1. Change Description

SCH-U340

Dual-Band Tri-Mode

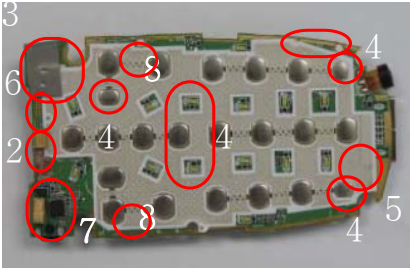
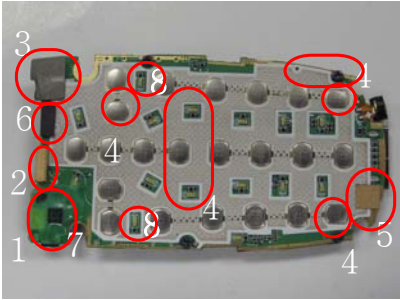
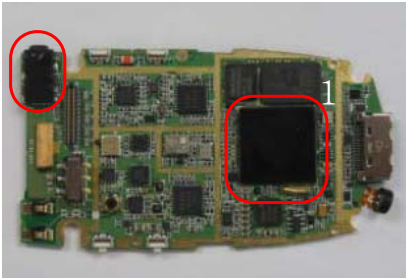
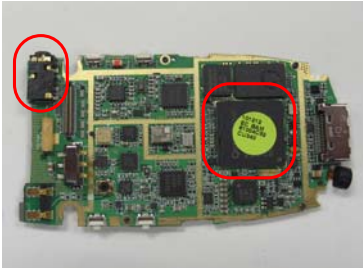
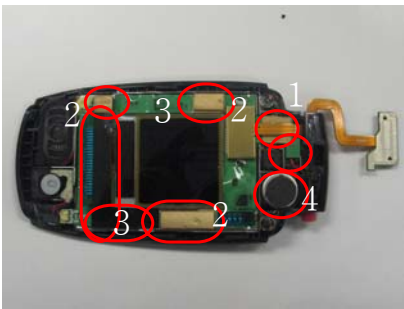
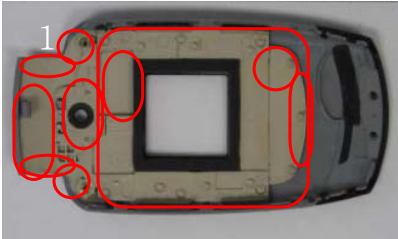
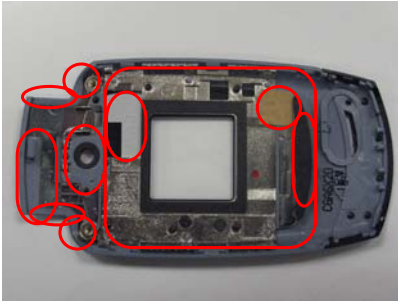
Previous Version	New Version	Remark
NA	Q101	PS_HOLD circuit added.
NA	LED314	KeyLED added.
U104(IC;SH248CSP)	U104(IC;A3212EELLT-T)	Hall effect IC changed.
NA	C227(VARISTOR;AVLC 5S 02 100)	Varistors added.
C300(C-CERAMIC,CHIP;GRM155R61A22 4KE19E)	C300(VARISTOR;AVLC 5S 02 100)	substituted varistor for capacitor
C304,C305,C306,C308,C318,C319,C322,C323,C324,C325 (C-CERAMIC,CHIP;GRP0335C1E10 1JD01E)	C304,C305,C306,C308,C318,C319,C322,C323,C324,C325(VARISTOR;AVLC 5S 02 100)	substituted varistor for shunt capacitor
NA	R208(R-CHIP;RC1005J472CS)	Full-up resistor added.
NA	R207,R347(R-CHIP;RC1005J103CS)	Power signal line resistor added.
R109(R-CHIP;RC1005J104CS)	R109(R-CHIP;RC1005J154CS)	Resistor changed
R320(R-CHIP;RC1005F1000CS)	R320(R-CHIP;WR0402X000JT)	
NA	R348(R-CHIP;MCR01MZP5J680)	KEY LED resistor added.
NA	R352(R-CHIP;MCR01MZP5F2202)	HFK data resistor added.
R201(R-CHIP;MCR006YZPJ222)	R201(R-CHIP;ERJ1GENJ472X)	Camera control line pull up resistor changed.

R202(R-CHIP;MCR006YZPJ222)	R202(R-CHIP;ERJ1GENJ472X)	Camera control line pull up resistor changed.
NA	R209(R-CHIP;ERJ1GENJ104X)	LCD I/O level tuning resistor added.
NA	R210(R-CHIP;ERJ1GEJ204C)	
R407(R-CHIP;ERJ2RKF5621X)	R407(R-CHIP;RK73H1ETTP5361F)	RF Rx matching circuit changed.
NA	C428(C-CERAMIC,CHIP;GRP1555C1H1R0C)	
R130(R-CHIP;RC1005J223CS)	R130(R-CHIP;MCR01MZP5F303)	Hall effect IC circuit changed.
C144(C-CERAMIC,CHIP;GRP1555C1H470J)	C144(C-CERAMIC,CHIP;GRP1555C1H120J)	
NA	C545(C-CERAMIC,CHIP;GRP1555C1H330J)	PAM Power stable circuit added.
NA	C546(C-CERAMIC,CHIP;GRM155R71A104K)	
C504(C-CERAMIC,CHIP;CM105X7R152K50AT)	C504(C-CERAMIC,CHIP;GRP1555C1H2R7BZ01E)	RF Tx matching circuit changed.
NA	C228(C-CERAMIC,CHIP;GRP0335C1E101JD01E)	Power signal line capacitor added.
NA	C348(C-CERAMIC,CHIP;GRM188F51A475ZE20)	VBATT overshoot protect circuit added.
NA	C147(C-CERAMIC,CHIP;CV105X5R475K10AT)	Capacitor added.

TA300(C-TA,CHIP;F951A336MSAAQ2)	TA300(C-TA,CHIP;TLCR476M010HTA)	VBATT overshoot protect circuit changed.
NA	C508(INDUCTOR-SMD;LL1005-FH15NJ)	RF Tx matching circuit added.
NA	C506(INDUCTOR-SMD;LL1005-FH5N6S)	
OSC302(CRYSTAL-UNIT;MS3V-T1R)	OSC102(CRYSTAL-UNIT;1TJT125DN1A106L)	Crystal changed
